## **DESIGN REVIEW BOARD DECISION**

**DATE:** October 14, 2019  
**FILE NUMBER:** DRV19-00306  
**PROJECT NAME:** KIRKLAND URBAN SOUTH (PHASE 2) PROJECT  
**APPLICANT:** Natasha Morris with CollinsWoerman  
**PROJECT PLANNER:** Scott Guter, AICP, Senior Planner

DESIGN RESPONSE CONFERENCE #3:  
9/4/2019

## Enlarged West Elevation

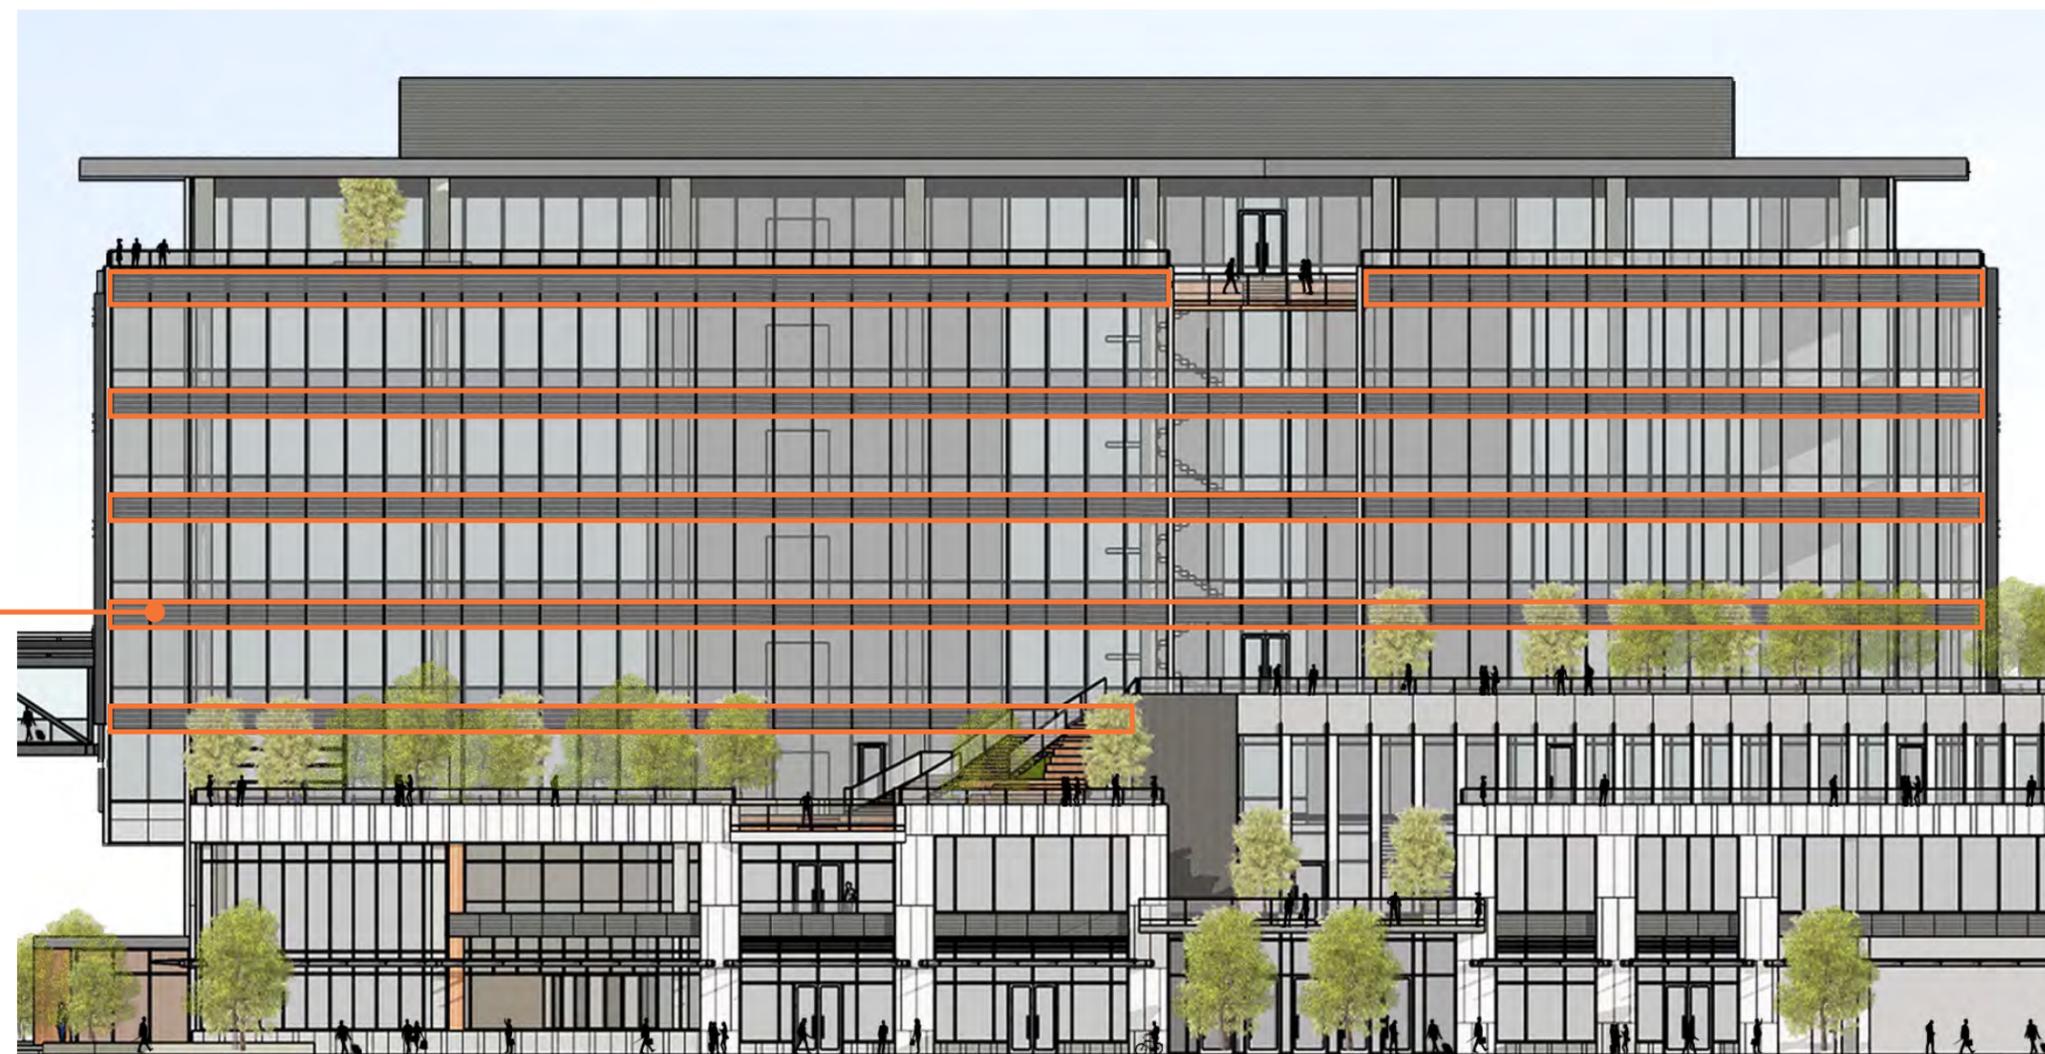
#### 1. West Facade Glare

- Investigate methods of reducing glare on the west facade, including adding shading devices and reducing the use of reflective coatings.

Vertical fin spacing has been decreased to 5' on center to increase the area of glass being shaded throughout the day, which should mitigate glare.

In addition, the low-e coating can be removed in areas of the facade with spandrel glass, which will allow the glass to be less reflective and cast less of a glare.

## Enlarged East Elevation

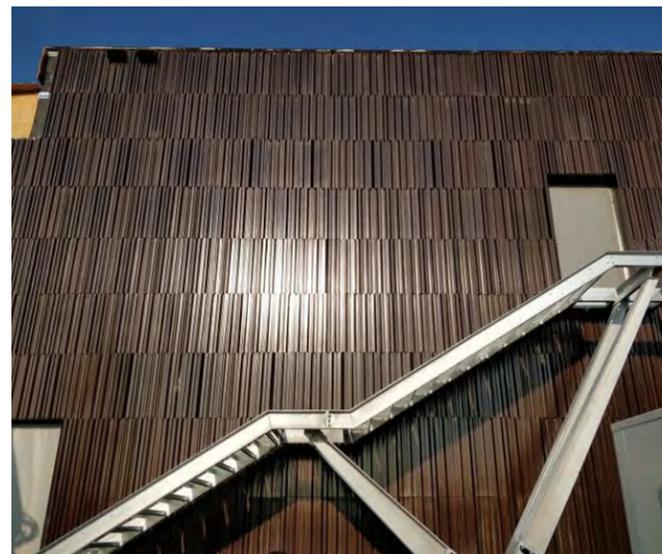
#### 3. East Facade Blank Wall

- Clearly identify materials to be used.
- Break up the scale of the upper wall with joints or other architectural elements

### Option 2

## SKYBRIDGE DESIGN

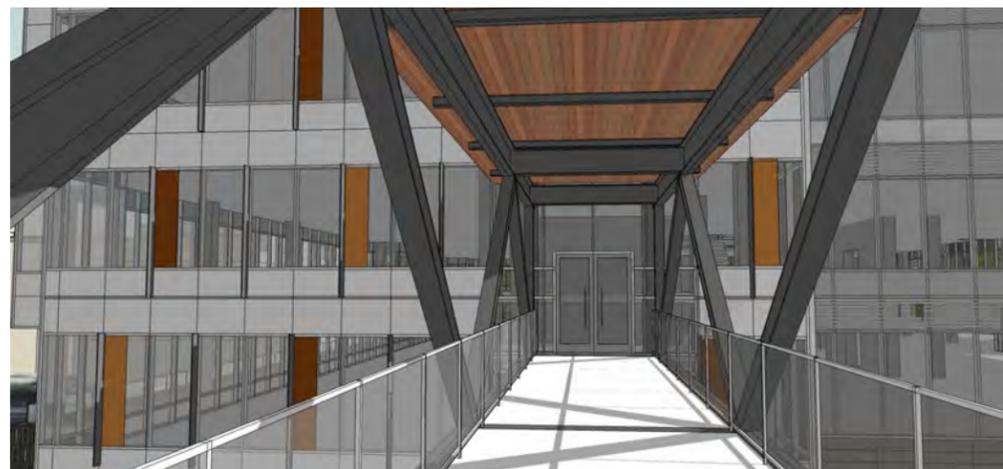
#### 4. Skybridge Design & Location

- Investigate moving skybridge to make it less visible from public spaces.
- OR design the bridge to be a sculptural element in its current location.

The skybridge has been moved back away from the park edge and public plaza, significantly reducing its span between the buildings. The design has been kept modest, blending in with the existing buildings.

Thought has been given to how it intersects each building on the ends, lining up with existing material lines on the Central building, and landing in a small notch on the South building.

# MINOR MODIFICATIONS

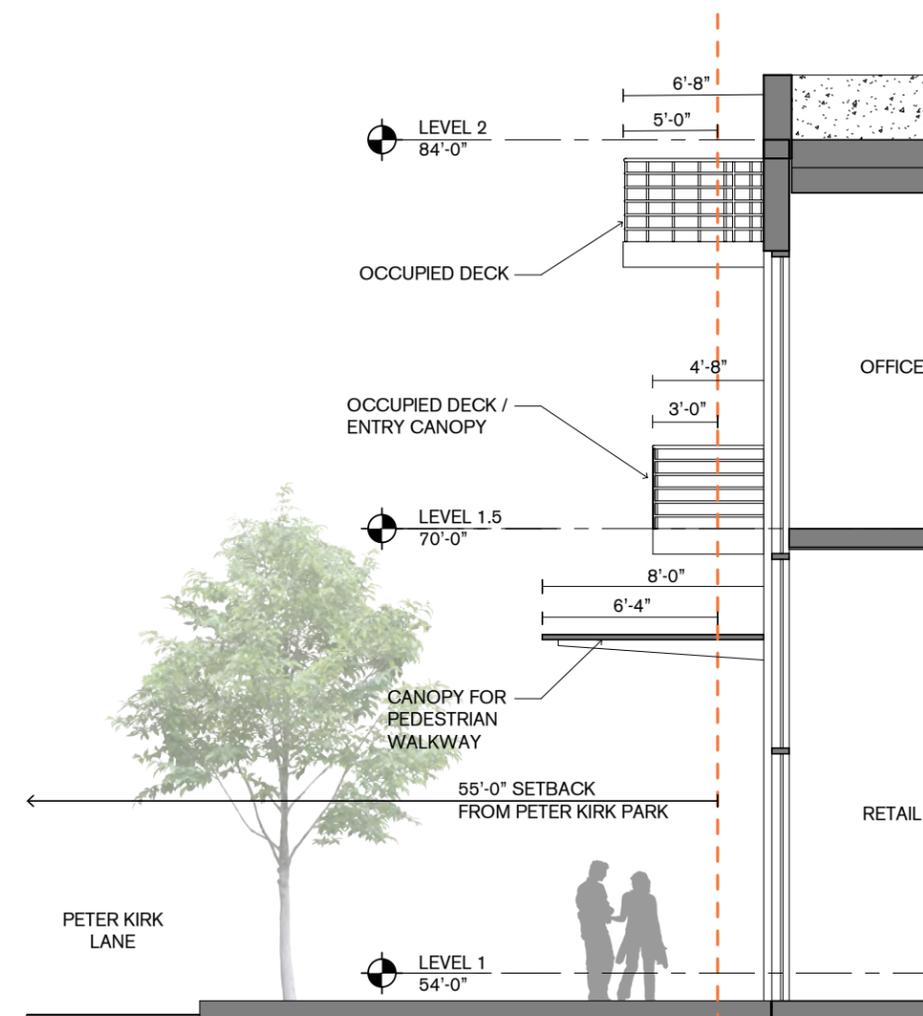
A minor modification to the 55 foot setback from Peter Kirk Park is requested for canopies and occupied decks that will project from the building face more than the 18 inches allowed per Section 115.115. 3.d. of the Kirkland Zoning Code.

The Master Plan and Design Guidelines encourage canopies at Retail frontage and at Pedestrian Pathways, and are noted in the Master Plan and Design Guidelines for the street section on Peter Kirk Lane (Park Promenade). The canopy at the main elevator lobby also doubles as an occupied deck at Level 1.5, responding to the Board's recommendation that the upper level decks occur at a level lower than the 30 foot tall building base. Another projecting deck at Level two serves to extend the activity of the Level two decks out towards the park, and is lowered to create better views both to to and from the park. It aligns with the feature stair connecting decks at levels two and three, and provides additional articulation in the podium.
